CALIFORNIA COASTAL COMMISSION

W4f

**STAFF REPORT: CONSENT CALENDAR****APPLICATION NUMBER:** 5-07-316**APPLICANT:** George Klein, Jr. **AGENT:** Sarai Grenell**PROJECT LOCATION:** 31 24th Avenue, Venice, City of Los Angeles, Los Angeles County**PROJECT DESCRIPTION:** Remodel and enlargement of an existing two-story, 2,165 square foot duplex resulting in a two-story, 28-foot high, 2,885 square foot duplex with three parking spaces on a 2,640 square foot lot fronting a walk street.

COASTAL COMMISSION
 5-07-316
 EXHIBIT # 4
 PAGE 1 OF 1

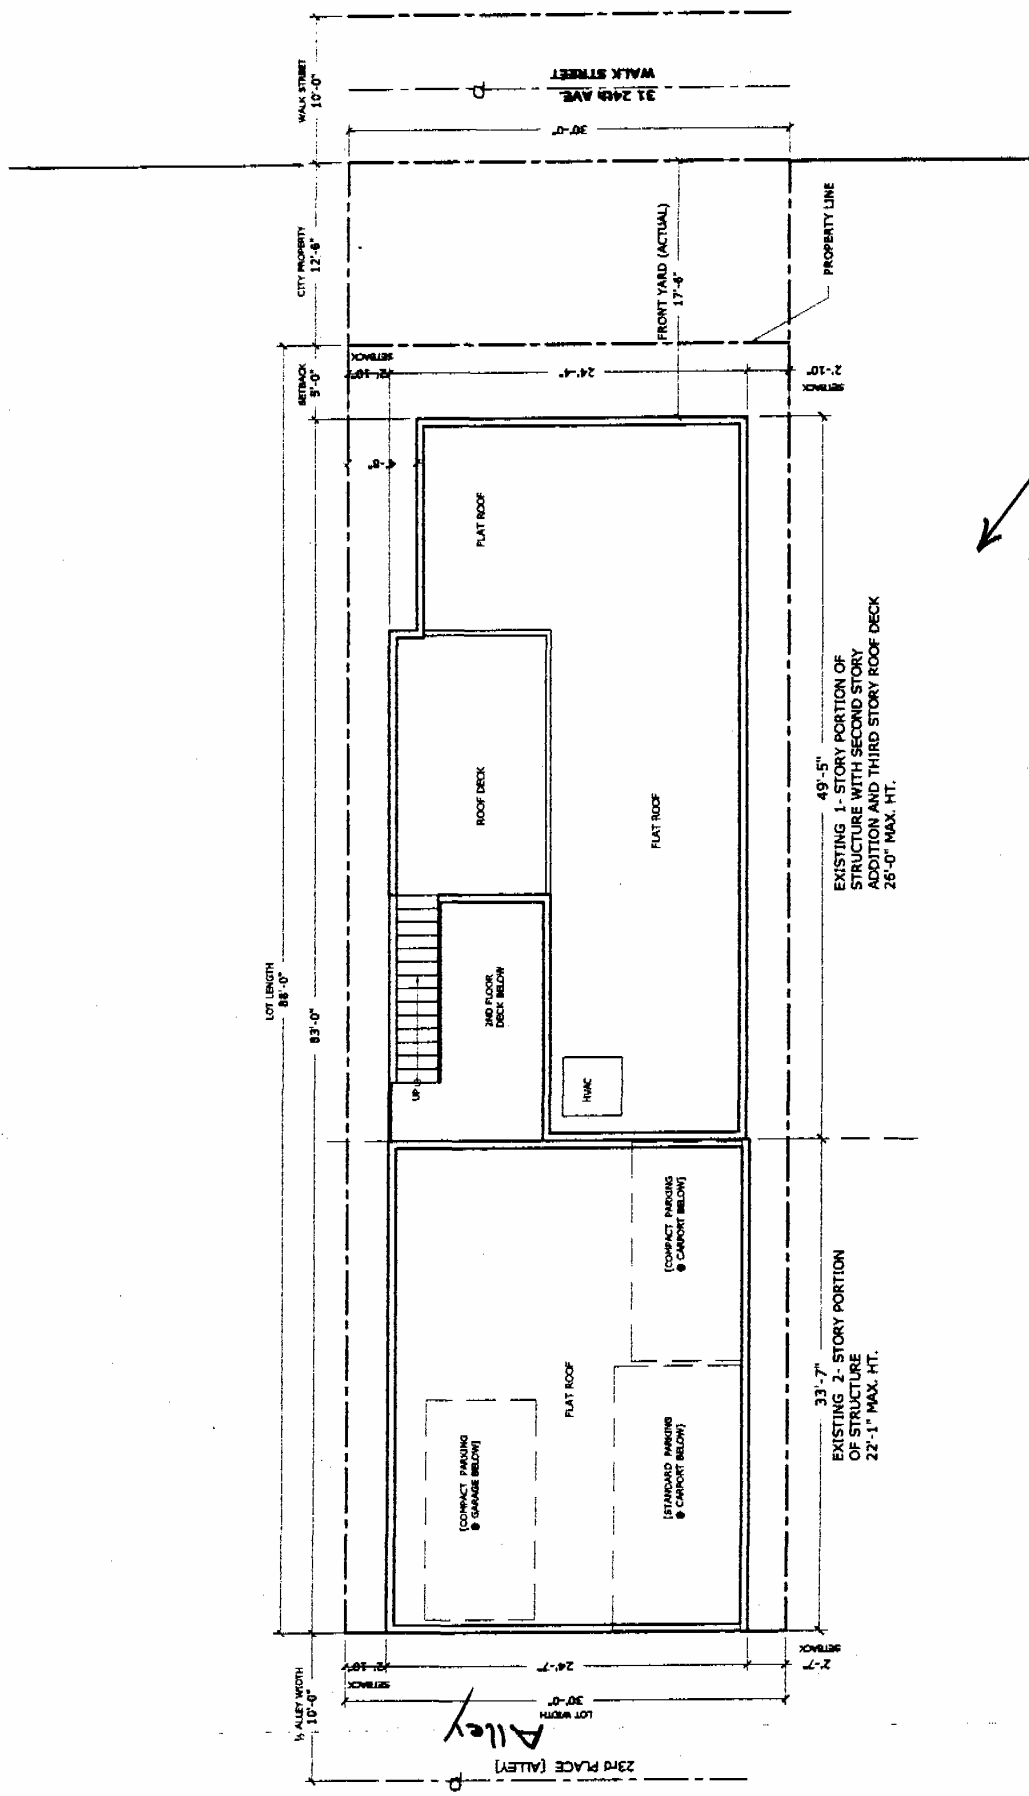
- a) Building Setback. In order to maintain an open and visible access corridor and to enhance visual quality, all balconies and other portions of the structure (except for ground level decks and porches that do not exceed thirty inches in height above the elevation of the walk street sidewalk) shall be set back at least five feet from the 24th Avenue right-of-way, **as shown on Exhibit #4 of the 11/20/07 staff report.**

The proposed second-floor addition is 28 feet in height, about five feet higher than the roofline of the existing two-story duplex (Exhibit #5). The existing three-car garage on the rear portion (alley-side) of the lot provides on-site parking (Exhibit #4). The rear alley (23rd Place) provides vehicular access to the garage, which will be maintained as part of the project. The front of the existing duplex is set back five feet from the 24th Avenue right-of-way, and the proposed addition is also set back five feet from the 24th Avenue right-of-way (Exhibit #4). The applicant has agreed to maintain the front yard setback area and a portion of the fronting right-of-way as a landscaped and permeable yard area as required by the certified Venice LUP.

EXHIBIT # 6

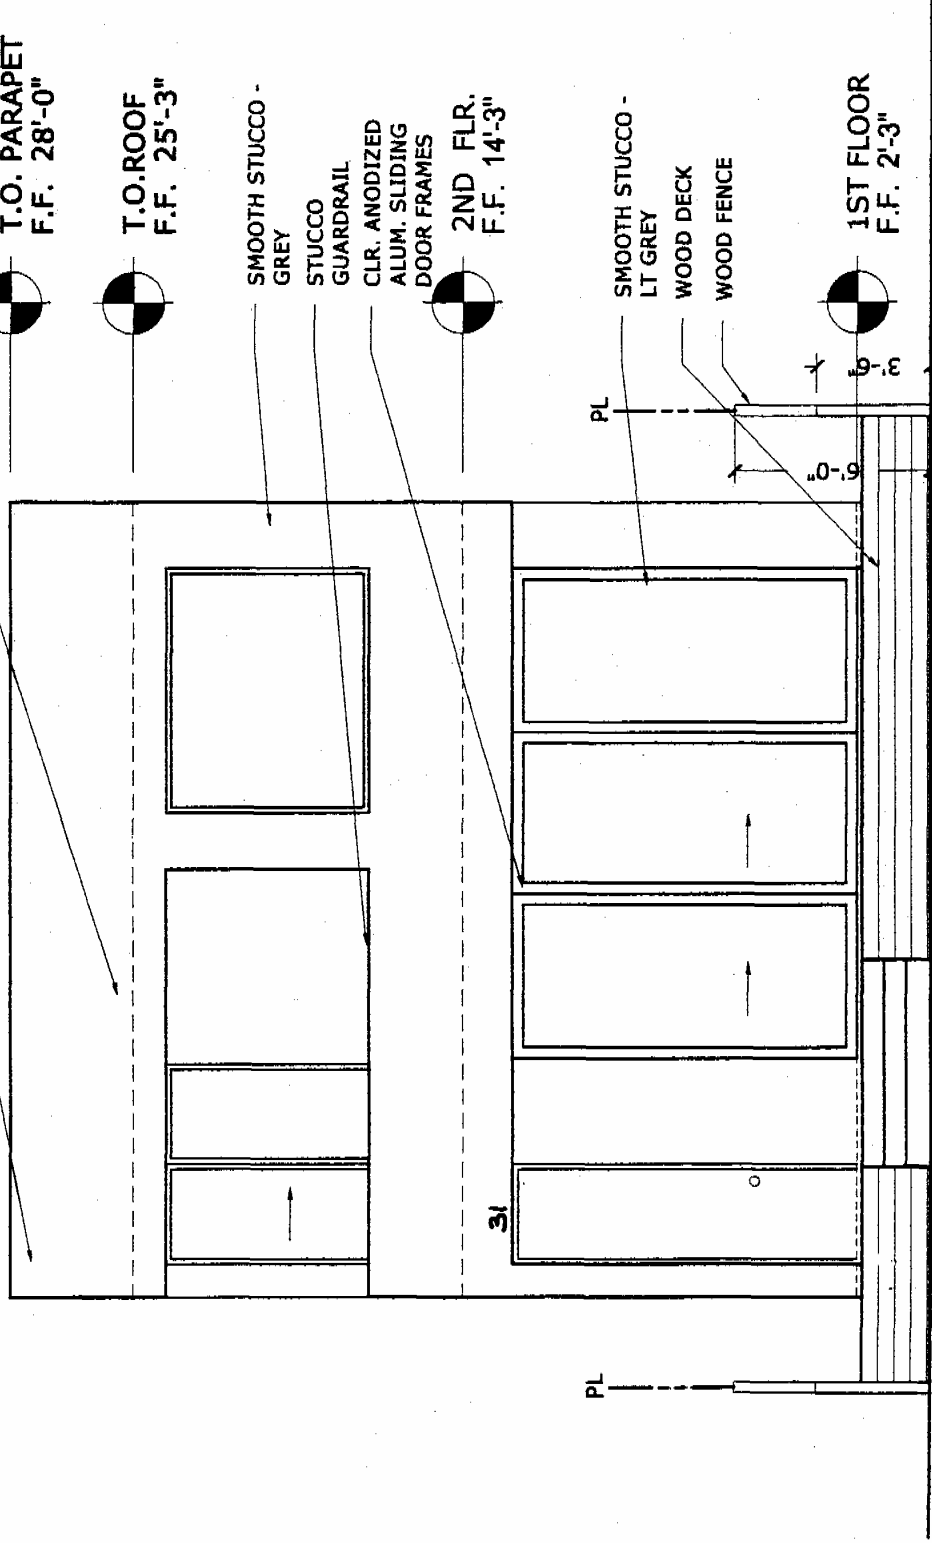
- b) Building Design. In order to enhance visual quality and community character, the side of the building facing the 24th Avenue walk street shall be designed and constructed with a varied and articulated façade that provides visual interest to pedestrians with frequent windows and the primary ground floor entrance for the residence facing the walk street, **as shown on Exhibit #6 of the 11/20/07 staff report.**

The proposed addition, with its 28-foot high roof, conforms to the 28-foot height limit for structures fronting on walk streets in Venice (Exhibit #6). The proposed project also maintains its existing on-site parking supply (three spaces in the garage), which is one space short of what would be required for a new duplex. Since the project is a remodel and addition of an existing duplex, and not a new duplex, the existing duplex is permitted to maintain its non-conforming on-site parking supply.
